**Re: O'Reily Auto Parts, 416 Candelaria Rd. NW,
Request for Permanent Certificate of Occupancy - Approved
Engineer's Stamp dated: 07-11-11, (G14/D022)
Certification dated 11-17-11**

**Re: O'Reilly Auto Parts Site Grading and Stormwater Plan
Engineer's Stamp date 9-20-10 (G14/D022)**

RE: O'REILLY AUTO PARTS – 416 CANDELARIA RD NW

Re: O'Reilly Auto Parts Grading Plan

1 SITE GRADING AND STORMWATER

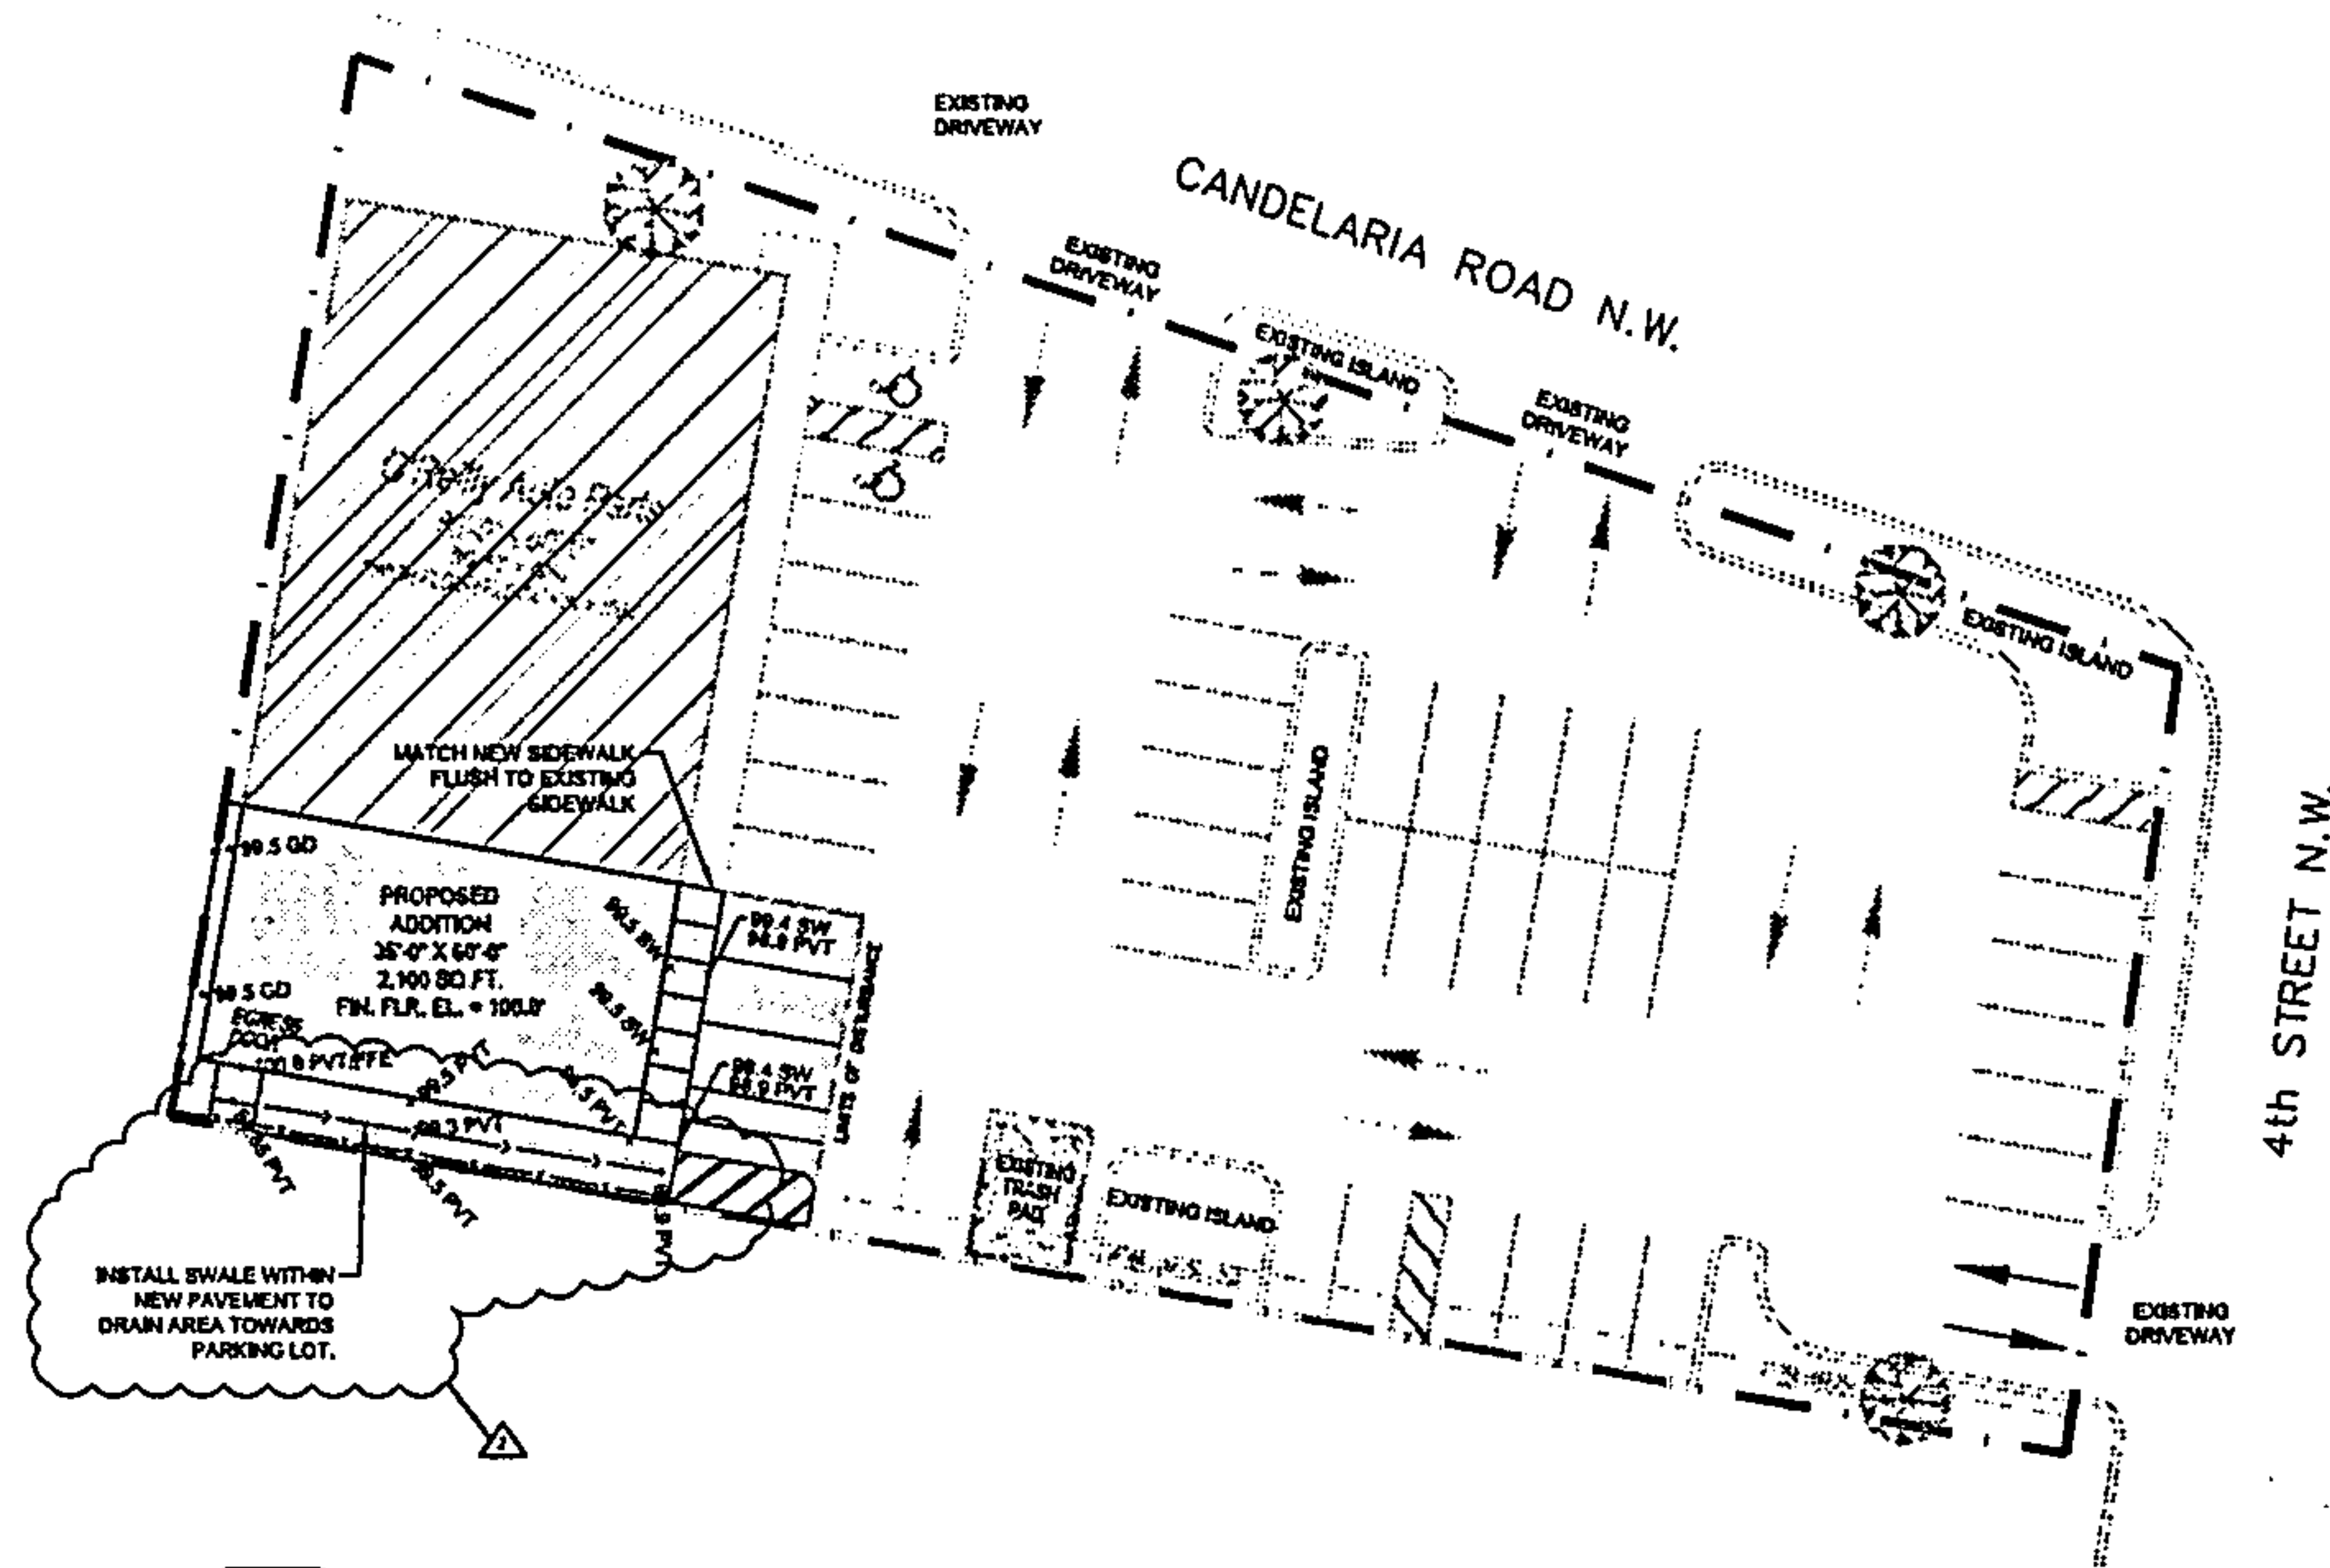
Comment #1: Generally, a Grading Plan will contain surveyed grades for the existing condition and proposed contours or spot elevations for the work to be performed. I realize this building addition will be constructed on an area that is mostly paved. Hydrology's concern is that roof flows may cross the property line to the west or south. To prevent this from happening, the revised Grading Plan should show the direction of roof flows and how the roof flows enter the main parking area. This will require more proposed spot elevations in the landscape area as well as spot elevations on the property line around the addition.

Comment #2: An engineered Grading Plan requires the signature and date of the Registered Engineer.

- Generally, a Grading Plan will contain surveyed grades for the existing condition and proposed contours or spot elevations for the work to be performed. I realize this building addition will be constructed on an area that is mostly paved. Hydrology's concern is that roof flows may cross the property line to the west or south. To prevent this from happening, the revised Grading Plan should show the direction of roof flows and how the roof flows enter the main parking area. This will require more proposed spot elevations in the landscape area as well as spot elevations on the property line around the addition.
- An engineered Grading Plan requires the signature and date of the Registered Engineer.

Response #1: Coordination has been made with the Architect to modify the building downspouts to discharge on the south side of the proposed building addition. Additional spot elevations and notes have been added to the grading plan directing the contractor to drain area east towards the parking lot.

Response #2: Revised Grading plans have been signed and sealed by a New Mexico Registered Engineer.

NEW SHEET C1 TO INCLUDE ADDITIONAL NOTES AND STORMWATER SUMMARY.
